SPM 11-030

Subject: GNF-A Response to NRC Request for Additional Information Dated 12/23/10
for Model No. RAJ-II Package

NRC RAI for RAJ-II Package – Docket No. 71-9309, TAC No. L24456:**Editorial Requests:**

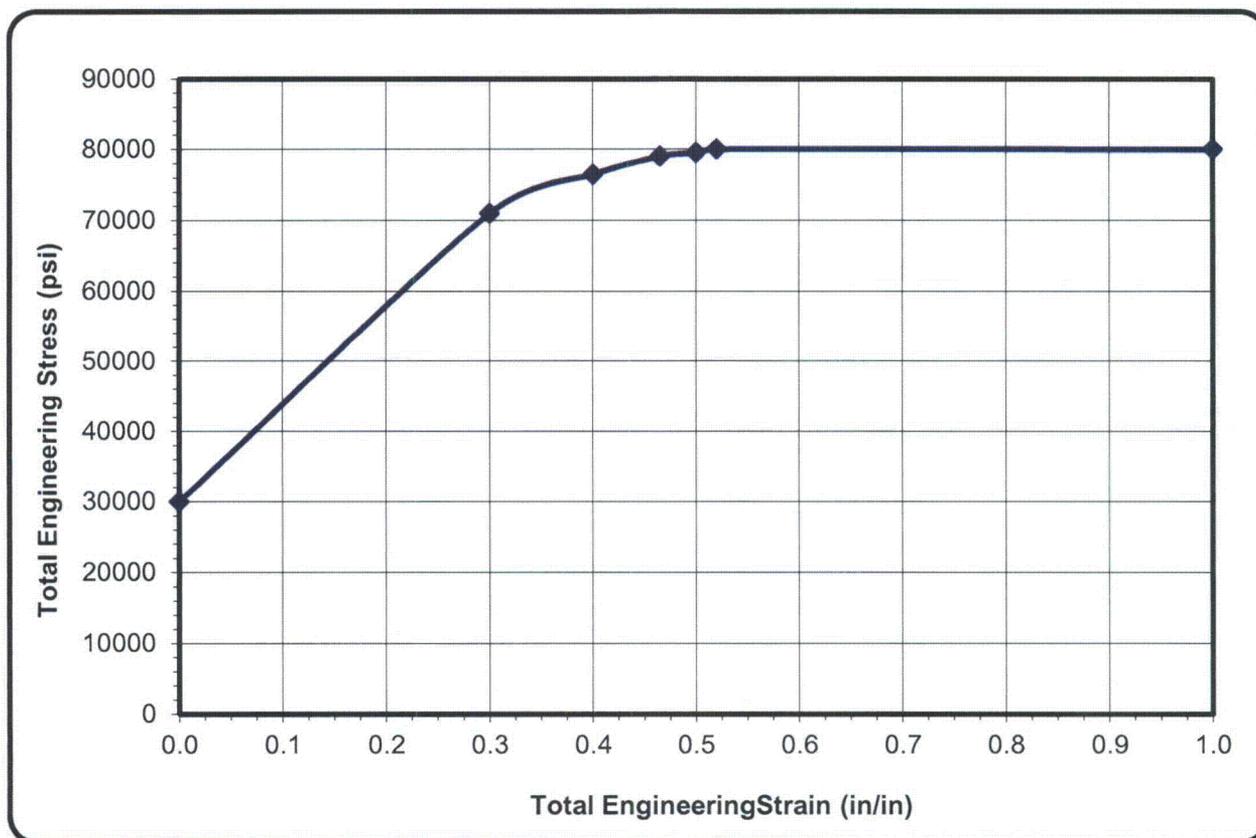
2-2 Revise plot on p 2-92. Plot of Total True Stress versus Plastic True Strain is plotted incorrectly or labeled incorrectly. The values shown in the plot are Total Engineering Stress versus Total Engineering Strain.

Plot on p 2-92 corrected as follows:

Figure 2-9.1. Combined Stress in Cladding During Load Step 3

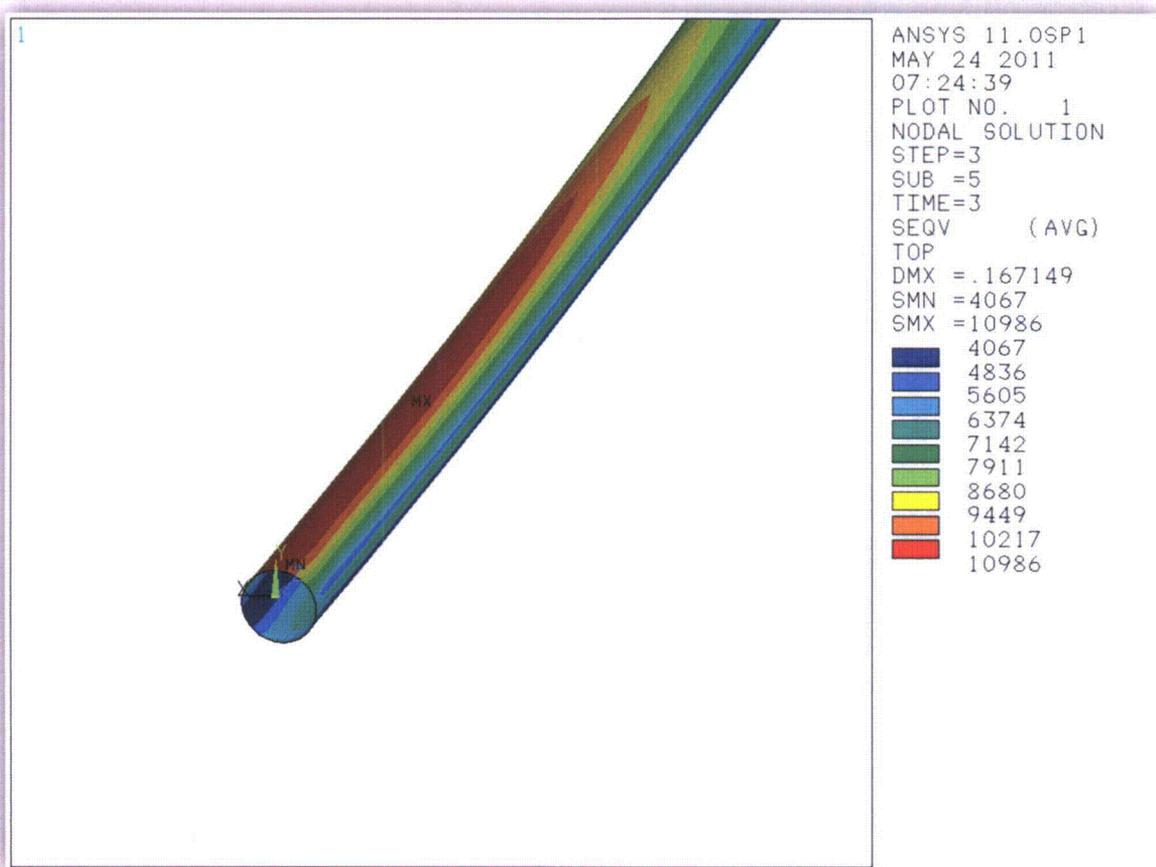
IRSN Questions:

To address the second question, the material model includes the coefficient of thermal expansion and the model is fixed at the cladding free end. Therefore, thermal stresses are accounted for from the initial ambient condition through the fire. The combined stress at the end plug of the fuel cladding is shown below.

Figure 2-12.1. Comparison of Japanese Top Drop Results and LS-DYNA Analyses

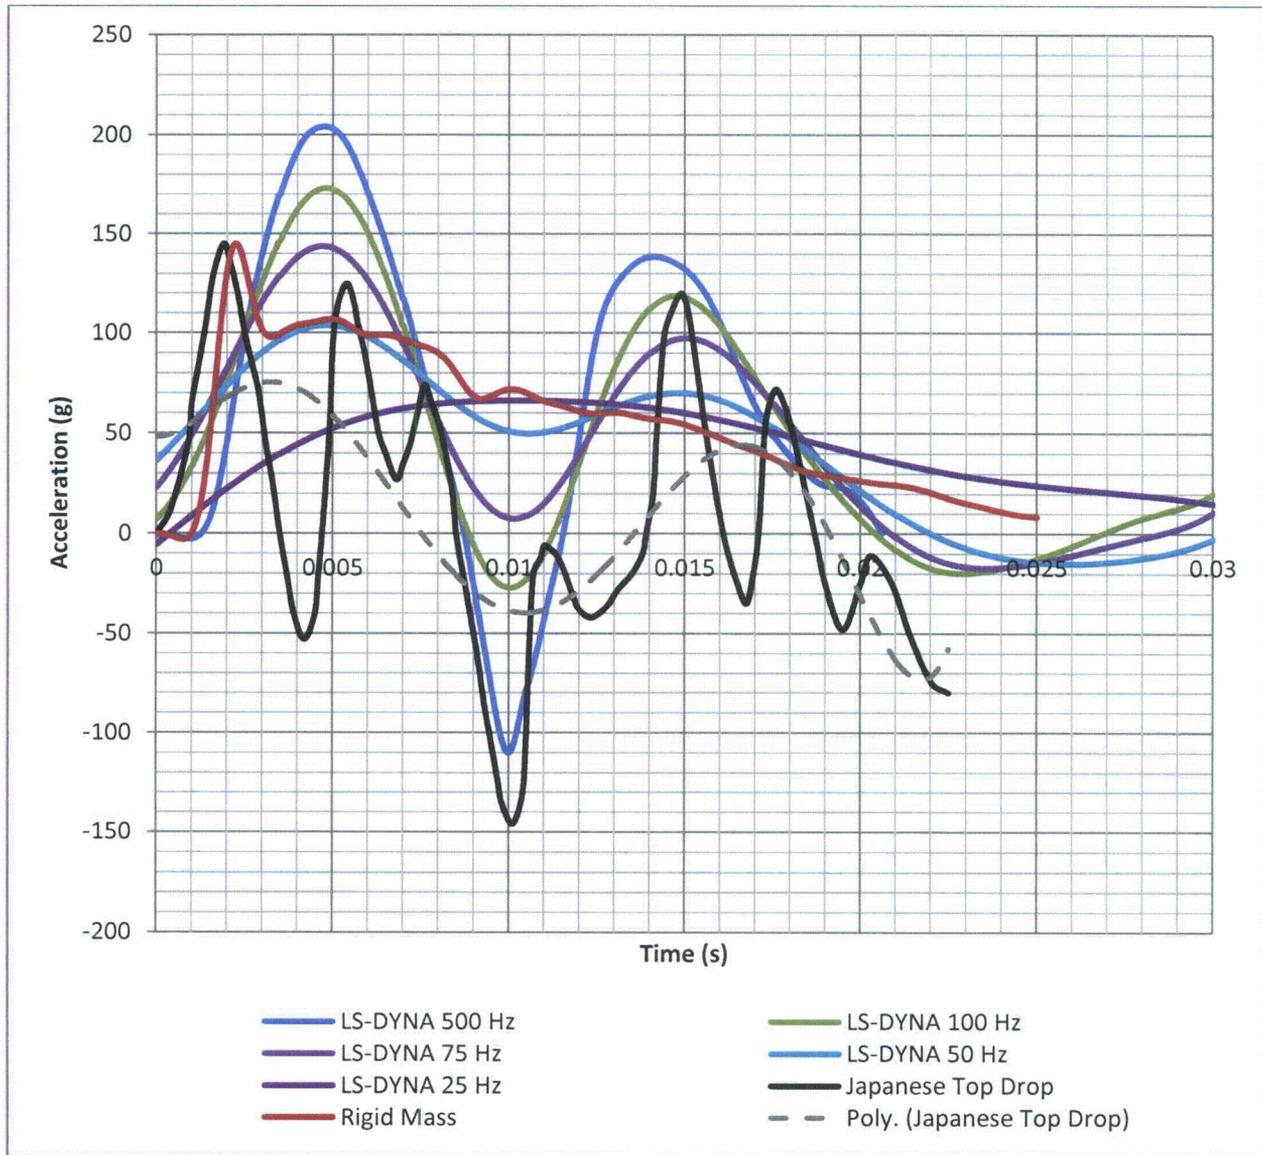
2-12 Provide sensitivity study demonstrating that rigid fuel payload is conservative. Staff does not have reasonable assurance that the assumption of rigid payload is conservative. Previous analyses performed by NRC staff have indicated that payload stiffness is a significant contributor to package response.

Acceleration time histories were recorded at the center of the bundle close to the location of the physical accelerometer in the drop test. Figure 2-12.1 was an overlay of drop test and LS-DYNA analysis results.

As Figure 2-12.1 showed, the Japanese top drop test results (black line) filtered at 500 Hz was compared with LS-DYNA filtered acceleration time-history results ranging from 25 Hz to 500 Hz. The rigid fuel bundle result was also provided for comparison (red line).

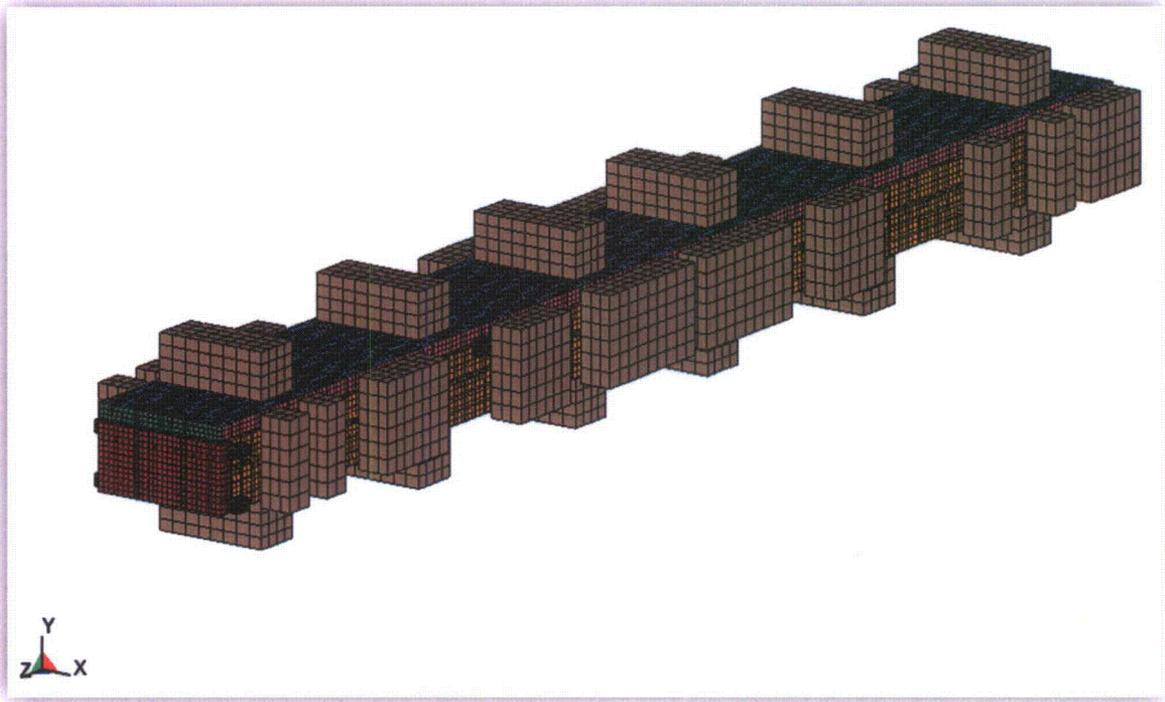
2-13 Provide a component study that demonstrates correct performance of paper honeycomb material. A simple crush evaluation for a representative honeycomb block when compared with test data provides reasonable assurance that the honeycomb block is providing the correct structural response with appropriate material properties.

To determine the correct performance of the paper honeycomb material, a simple model was developed. The model was run to show the input stress-strain curves resulted in accurate stress results.

The material model was further refined using the sub-model shown below by benchmarking the honeycomb crush with the drop test results, solving interface and negative volume problems, and verifying total kinetic energy. Further discussion was provided in the response to RAI 2-17. Once this study was complete, the outer container was added to the final model.

Figure 2-15.1 Cross-Section RAJ-II Package

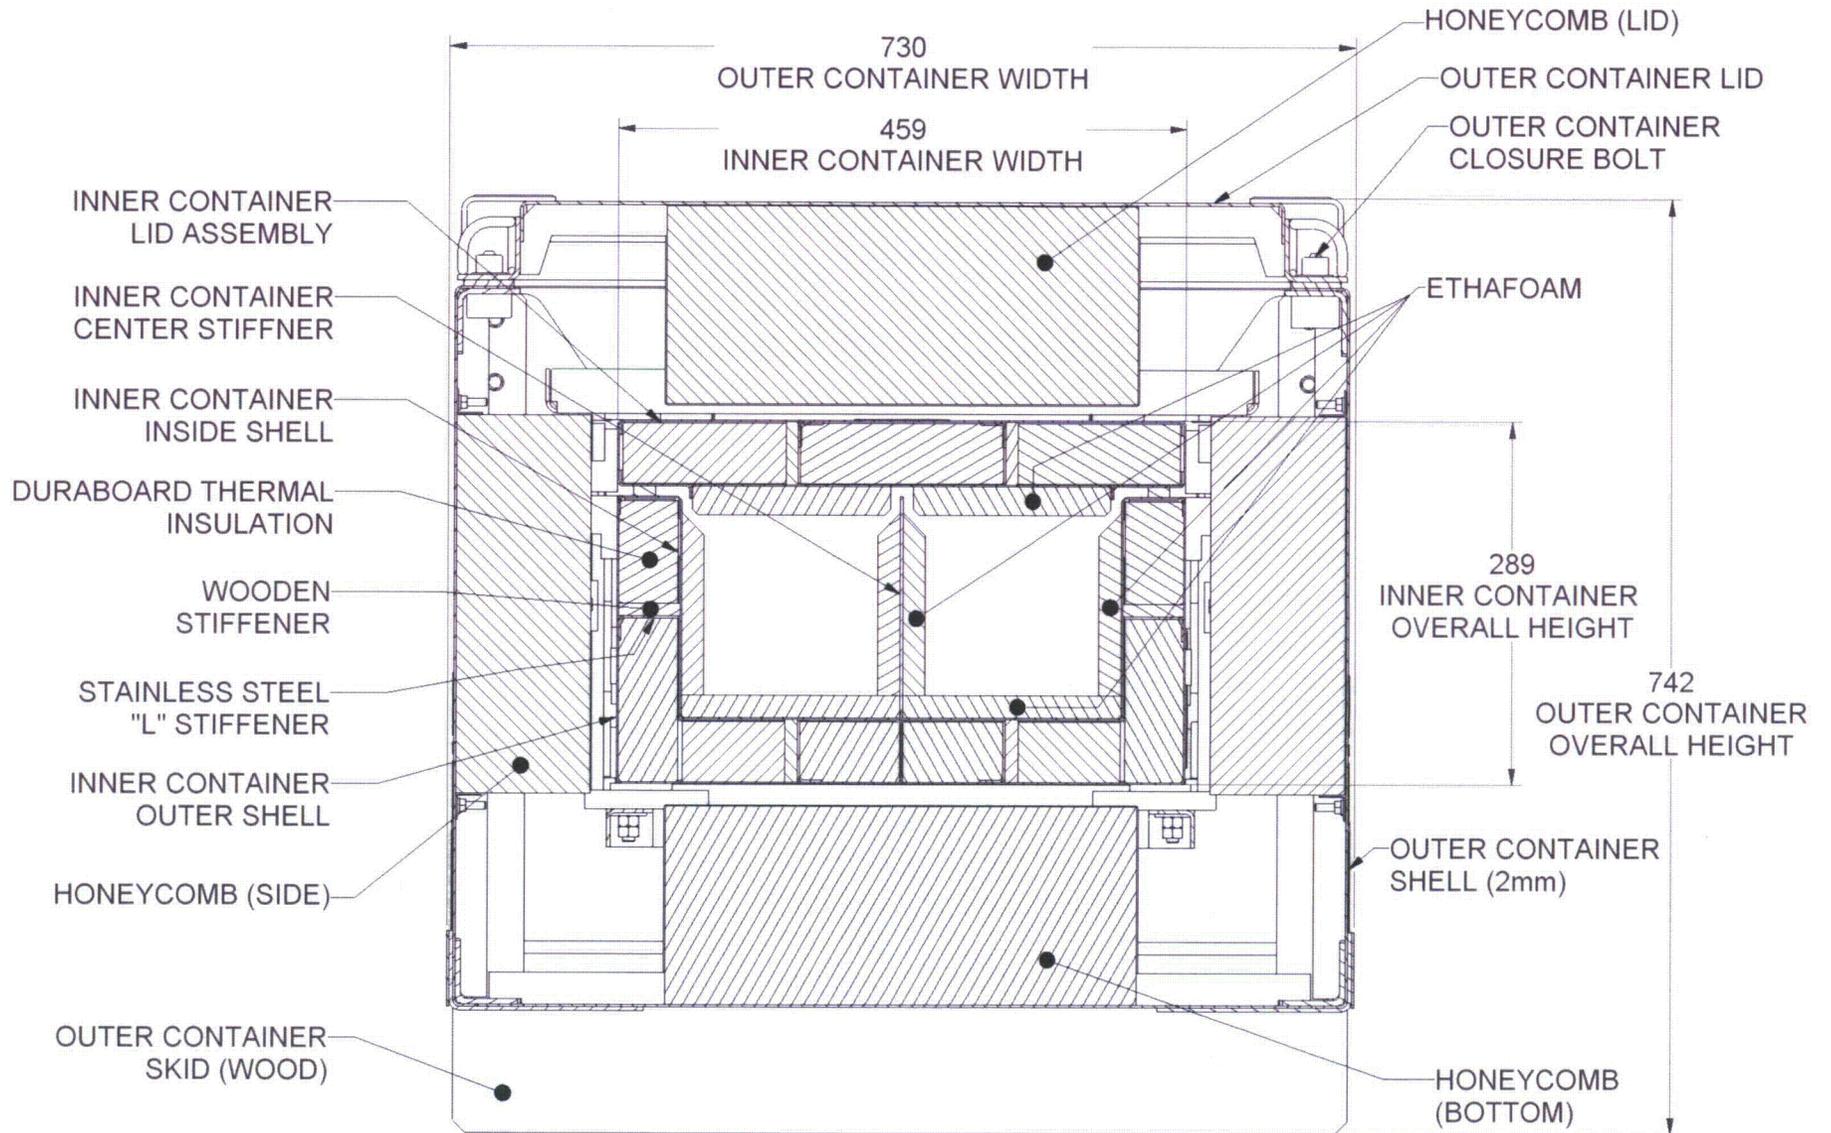
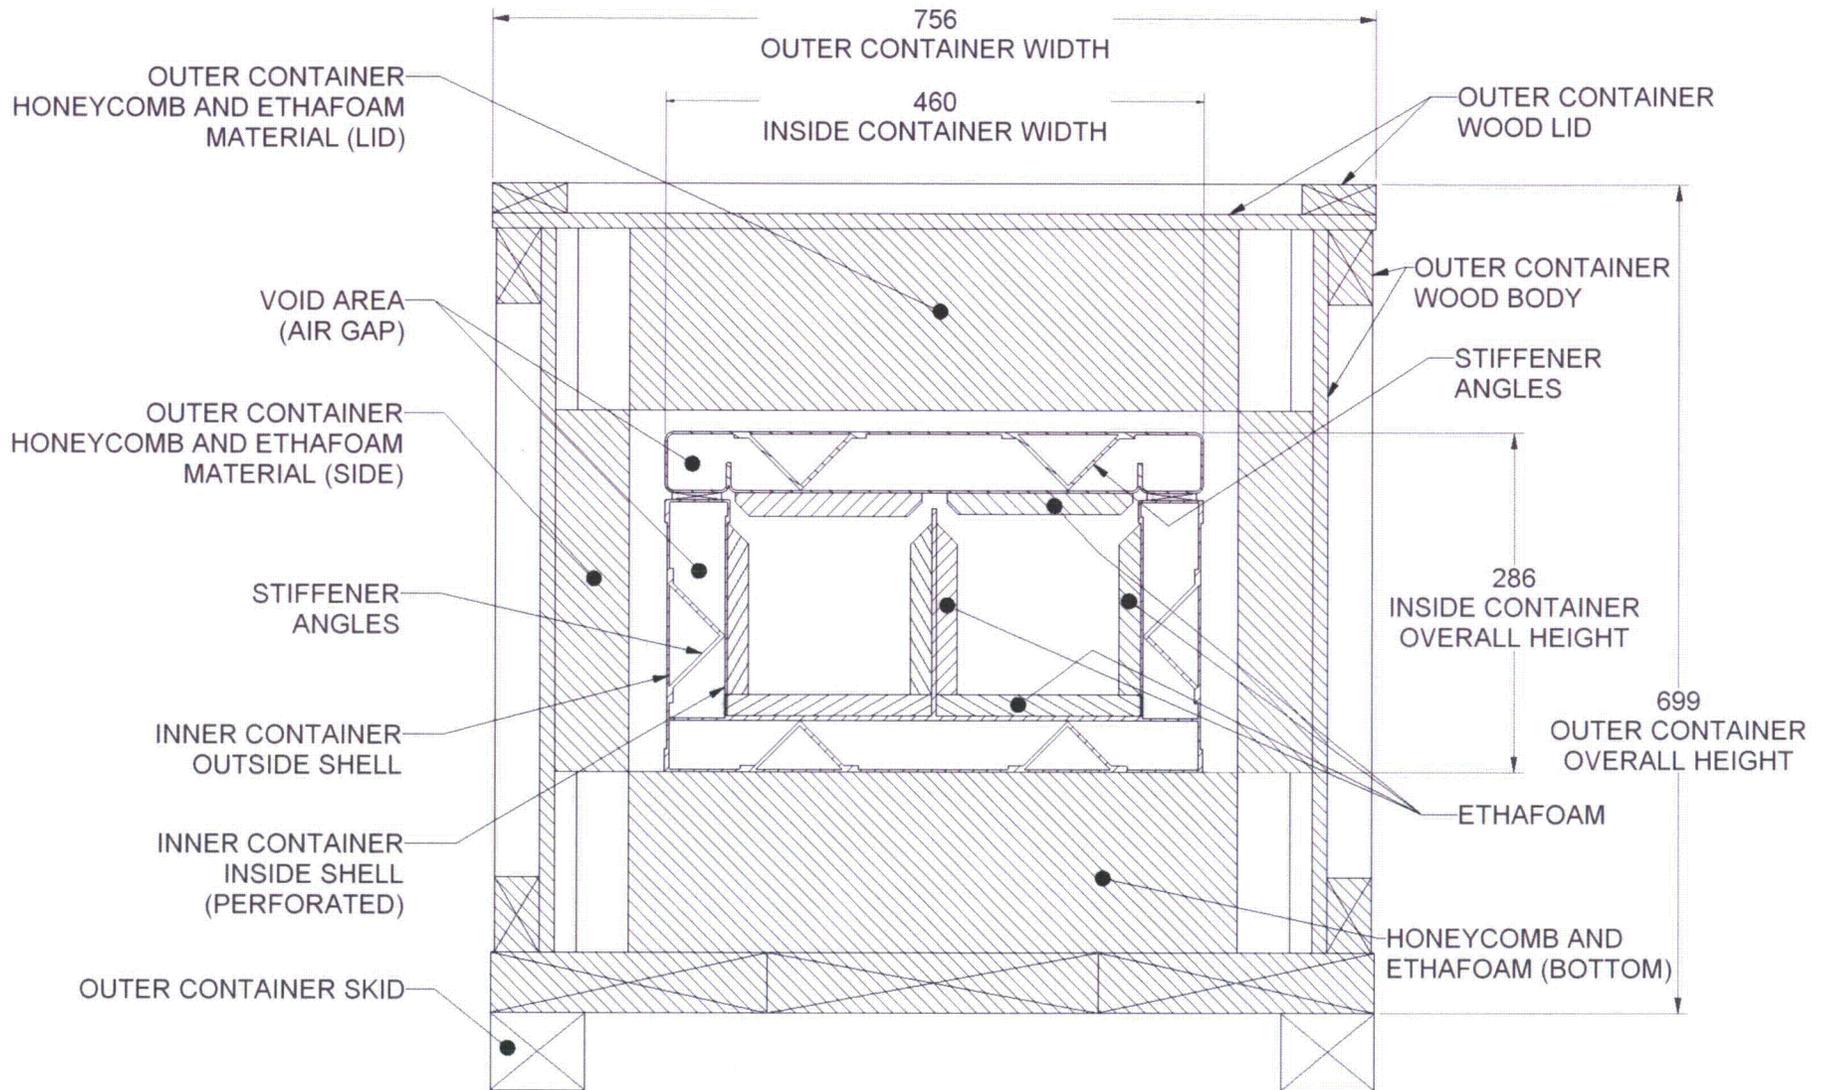
2-15 Provide comprehensive engineering comparison of the RAJ-II and the RA-3D package to demonstrate similarity. The applicant states that these packages are similar but no objective information is provided to demonstrate that this statement is accurate.

Because of limitations at the customer facility, the RAJ-II inner container design was changed little from the original RA-3. Like the RA-3D, the RAJ-II inner container was constructed of stainless steel. Unlike the RA-3D, the RAJ-II inner container included Alumina-Silicate insulation to protect the fuel bundles during the regulatory fire event. Figures 2-15.1 and 2-15.2 show the design features of the RAJ-II and RA-3D, respectively.

Figure 2-10.1. Comparison of RAJ-II Top Drop and LS-DYNA results (Center of Bundle).

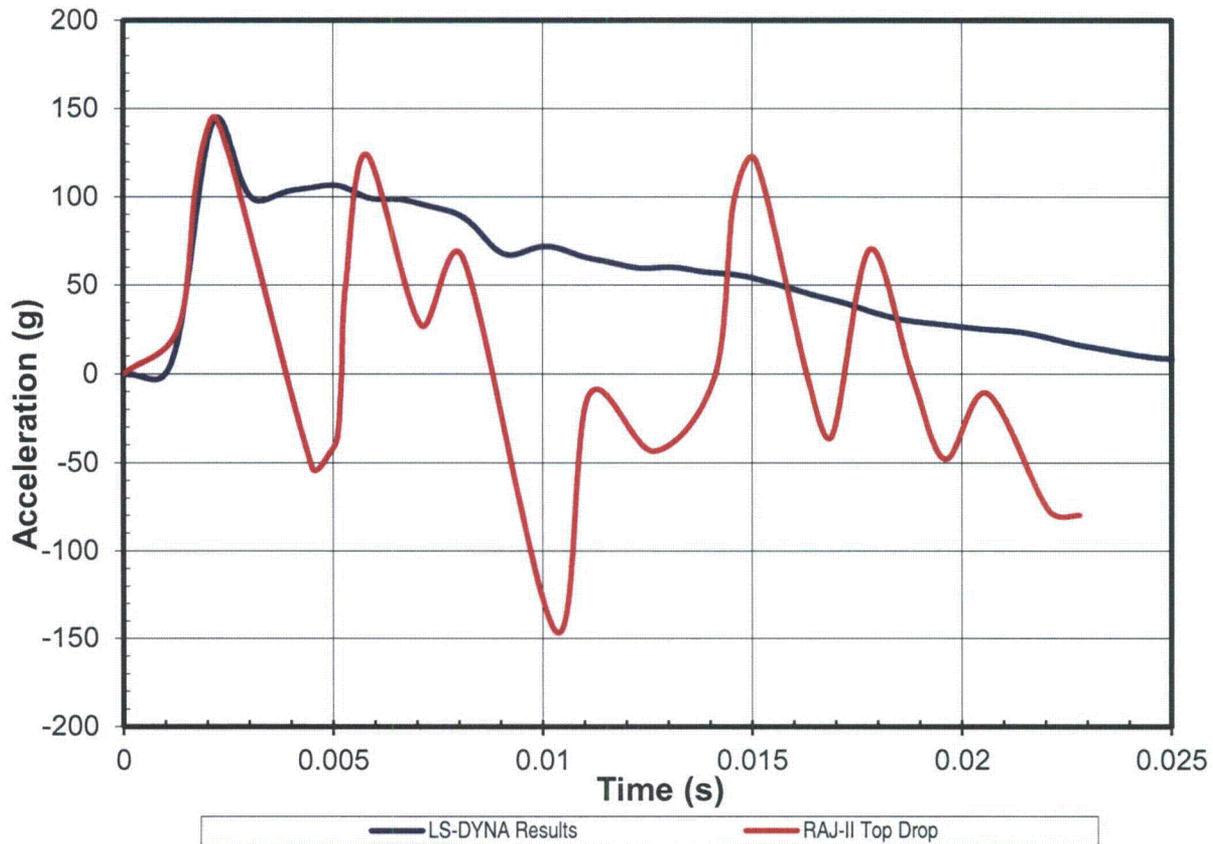
2-20 Provide overlay plots of the acceleration time histories for CTUs and FEA models. Acceleration time history shape as well as peak values are important to verify whether an analytical model is sufficiently robust to capture dynamic behavior.

The following curve shows the results of Japanese top drop test and LS-DYNA analysis results. The sensor location for both the analysis and test was on the fuel bundle. As the test curve shows, the sensor recorded the elastic response of the bundle during the impact. This data was chosen as the initial benchmark to verify the LS-DYNA honeycomb model with the drop test results. As discussed in the response to RAI 2-17, the measured crush of the honeycomb was 1.9 inches.
